Affected Date Code: **11/15/2022**

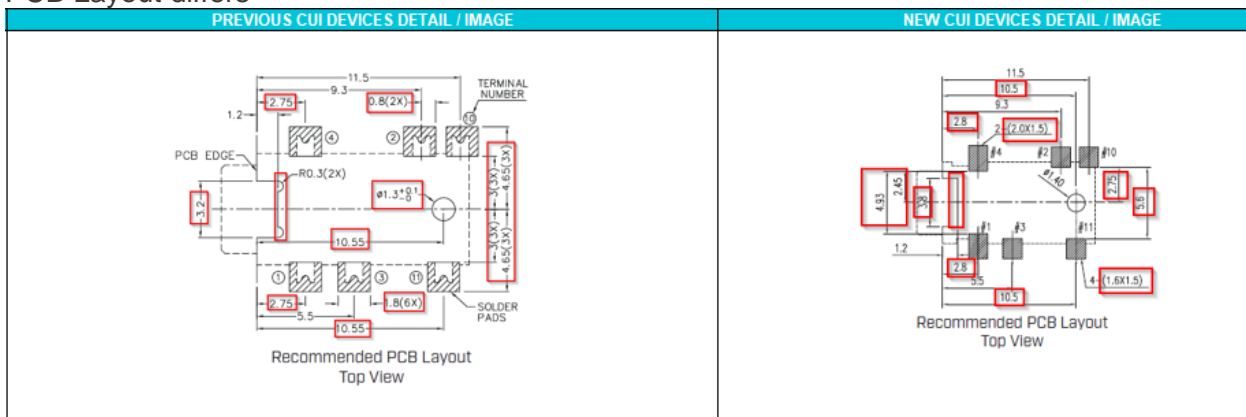
2. PCB Layout differs

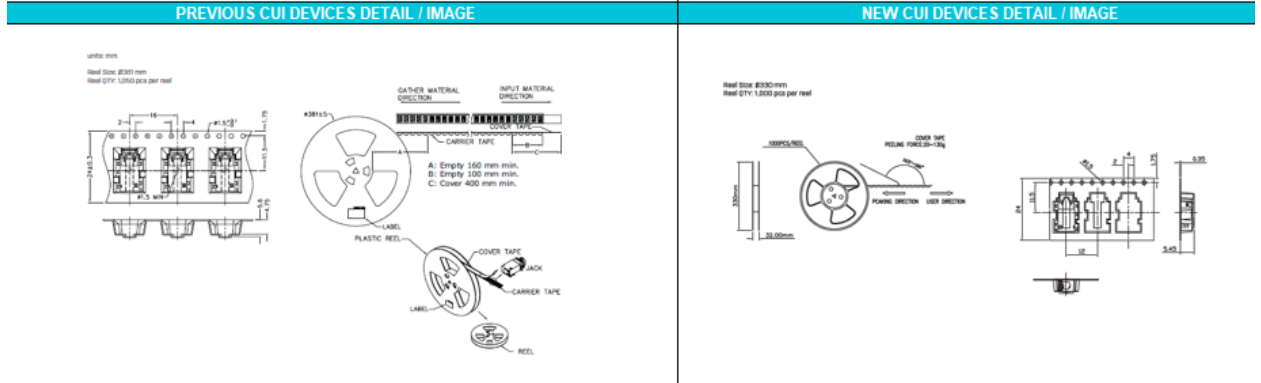
3. Housing material differs

PREVIOUS CUI DEVICES DETAIL / IMAGE	NEW CUI DEVICES DETAIL / IMAGE																																																
	<table border="1"> <thead> <tr> <th></th> <th>MATERIAL</th> <th>PLATING</th> </tr> </thead> <tbody> <tr> <td>terminal 1</td> <td>copper alloy</td> <td>gold flash</td> </tr> <tr> <td>terminal 2</td> <td>copper alloy</td> <td>gold flash</td> </tr> <tr> <td>terminal 3</td> <td>copper alloy</td> <td>gold flash</td> </tr> <tr> <td>terminal 4</td> <td>copper alloy</td> <td>gold flash</td> </tr> <tr> <td>terminal 10</td> <td>copper alloy</td> <td>gold flash</td> </tr> <tr> <td>terminal 11</td> <td>copper alloy</td> <td>gold flash</td> </tr> <tr> <td>plastic</td> <td>PA10T</td> <td></td> </tr> </tbody> </table>		MATERIAL	PLATING	terminal 1	copper alloy	gold flash	terminal 2	copper alloy	gold flash	terminal 3	copper alloy	gold flash	terminal 4	copper alloy	gold flash	terminal 10	copper alloy	gold flash	terminal 11	copper alloy	gold flash	plastic	PA10T		<table border="1"> <thead> <tr> <th></th> <th>MATERIAL</th> <th>PLATING</th> </tr> </thead> <tbody> <tr> <td>terminal 1</td> <td>copper alloy t=0.20</td> <td>gold flash over nickel</td> </tr> <tr> <td>terminal 2</td> <td>copper alloy t=0.25</td> <td>gold flash over nickel</td> </tr> <tr> <td>terminal 3</td> <td>copper alloy t=0.20</td> <td>gold flash over nickel</td> </tr> <tr> <td>terminal 4</td> <td>copper alloy t=0.25</td> <td>gold flash over nickel</td> </tr> <tr> <td>terminal 10</td> <td>copper alloy t=0.25</td> <td>gold flash over nickel</td> </tr> <tr> <td>terminal 11</td> <td>copper alloy t=0.20</td> <td>gold flash over nickel</td> </tr> <tr> <td>housing</td> <td>PA9T (UL94V-0)</td> <td>black</td> </tr> </tbody> </table>		MATERIAL	PLATING	terminal 1	copper alloy t=0.20	gold flash over nickel	terminal 2	copper alloy t=0.25	gold flash over nickel	terminal 3	copper alloy t=0.20	gold flash over nickel	terminal 4	copper alloy t=0.25	gold flash over nickel	terminal 10	copper alloy t=0.25	gold flash over nickel	terminal 11	copper alloy t=0.20	gold flash over nickel	housing	PA9T (UL94V-0)	black
